Attachment B

WILLIAM STREET CONSULTATION SUMMARY

QUEEN STREET CONSULTATION SUMMARY

Queen Street, Beaconsfield Inroad Planting - Updated Plan

UPDATED QUEEN STREET DESIGN – COMMUNITY GRAPHIC

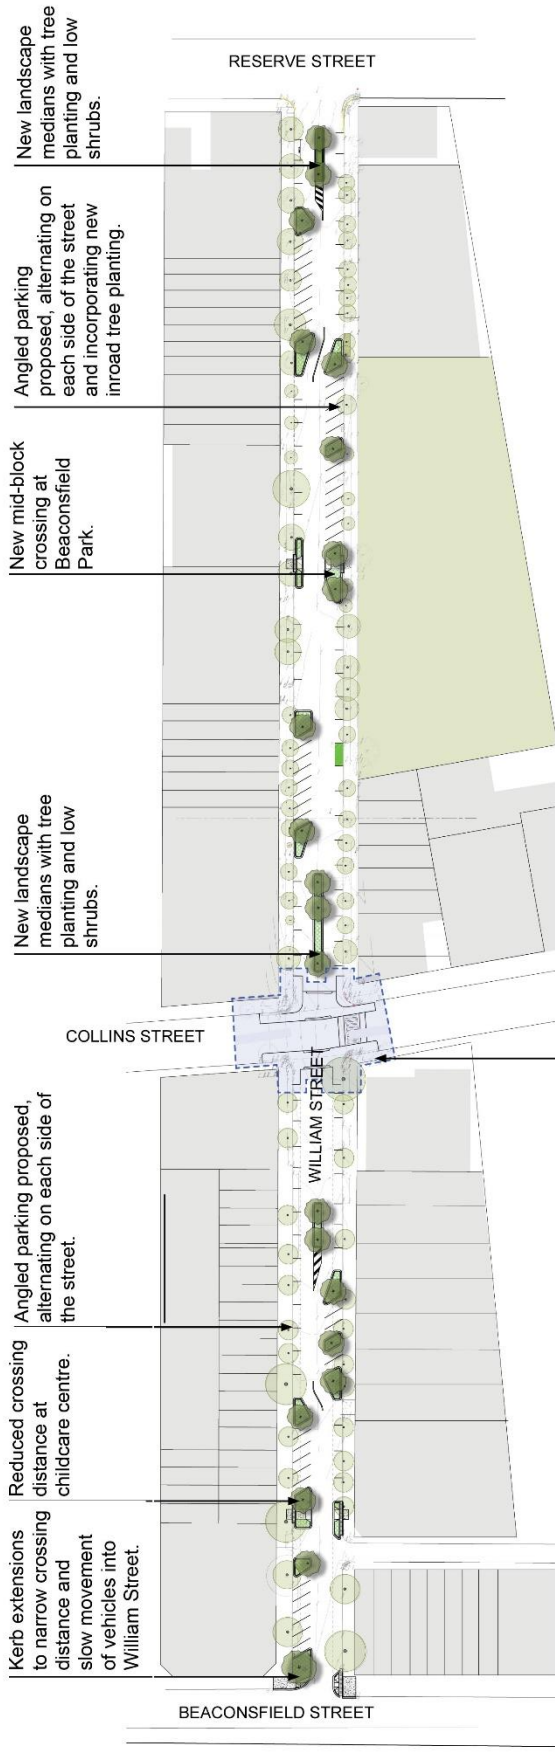
Submission Comment	Response
Twenty-seven submissions did not support the proposal as they considered there was sufficient trees already present and providing shade particularly between Collins and Reserve Street.	The proposal for additional tree planting on Queen Street supports the City's long-term approach to the provision of canopy. The majority of canopy is currently being provide by a small number of large Ficus Hilli trees which are generally not suitable footpath trees. The updated design has reviewed proposed tree locations to focus on locations where there is low areas of existing canopy.
Six submission comments were concerned about additional leaf drop and impact to drainage.	Noted as a comment.
Four submission comments were concerned that the species selection will add to existing problems of bats and possums.	Noted as a comment.
Two submissions recommended the focus should be on footpath planting rather than inroad planting.	The City has an ongoing program of proactive tree planting in the footpath across the LGA. The scope of this project focuses on inroad planting.

Eight submissions were concerned that additional trees will limit solar access to adjacent properties.	As part of the Street Tree Master Plan review the proposed tree species were amended to reflect these comments with the following species nominated: Between Beaconsfield Street and Reserve Street <i>Koelreuteria bipinnata</i> – Chinese Rain Tree Between Reserve Street and Johnson Street <i>Waterhousea floribunda</i> – Weeping Lilly Pilly
One submission challenged the benefit of a tree planting vs the associated concrete CO2 emissions.	The City has a tree planting program and canopy targets due to the many benefits of trees in an urban environment in addition to carbon sequestration, however it is noted as a comment and the delivery team is working towards minimising where suitable the volume of concrete required for the installation of trees in the road way.
One submission recommends removing overhead powerlines.	The City supports a program of both undergrounding services and bundling cables to improve tree canopy outcomes. This is not proposed as part of this project scope.

Two submissions did not support median strip as a traffic calming device.	Median strips are part of a suite of traffic treatments used within the LGA on local roads to provide greening and traffic calming.
One submission comment requested the median strips be reduced in width.	Minimum size of medians is 2m to accommodate suitable soil volumes for tree planting. Medians are only proposed on streets with sufficient space to accommodate compliant parking and travel lane.
One submission was concerned that active transport users, pedestrians, mobility devices will be limited in their ability to cross the street and be in conflict at locations where u turns are possible and at driveways.	Improved crossing distances have been provided at key locations. The reduction of median strips also ensures that informal movement across the street will be maintained.
Six submissions noted there was generally insufficient parking.	Through the provision of angled parking an additional 10 spaces have been located along the street, this has been balanced against the need to provide suitable locations for inroad planting.

Two submissions did not support the proposal between Reserve Street and Collins Street due to Canopy, but supported north of Collins Street.	Refer to updated design. The updated design focuses on additional canopy in areas of low canopy as well as the provision of some future inroad planting adjacent the large existing canopy trees.
Two submissions recommended improving crossing in front of the park rather than a proposed median.	Refer to updated design. Improved crossing points have been provided at the park.
Four submissions were concerned about speeding due to the width of the street and the use of the street as a rat-run. Three submissions requested additional traffic calming devices near the park.	The proposed works will introduce a series of traffic calming devices to reduce speed and improve pedestrian safety on these streets. The interventions will also serve as a direct deterrent to the use of the street as a rat-run by slowing the speed on the street through the traffic treatments.

Three submissions made the comment there was no issue with traffic on Queen Street.	Noted as a comment.
Three submissions were concerned that the proposal will impact parking. One submission was concerned it will block driveways.	There will be some changes to parking, however there will be an overall gain of parking spaces across the precinct. All driveways will maintain there current access arrangements.
One submission likes the width of the street as it is.	Noted as a comment.
One submission requested additional information regarding timing of the works and temporary parking impacts.	Residents will be kept up to date through the approvals process and through standard construction notification processes. There will be some impact to parking through the construction program.
One submission was concerned the proposal will enable cutting down of large trees.	No proposed trees to be removed as part of this proposal, however by proactively planting trees on this street it will allow Council to appropriately

- Utilisation of both angled parking and median strips as traffic treatments to slow traffic and provide opportunities for inroad planting.
- Increased angled parking in sections of Queen Street to have a net increase of 10 parking spaces whilst also providing additional tree planting in the roadway.
- Inclusion of chicanes in William Street in both blocks to slow traffic
- Provision of a mid-block crossing at Beaconsfield Park to reduce crossing distances and improve pedestrian safety.
- Kerb-extensions at the William and Beaconsfield intersection to reduce crossing distances and narrow roadway.
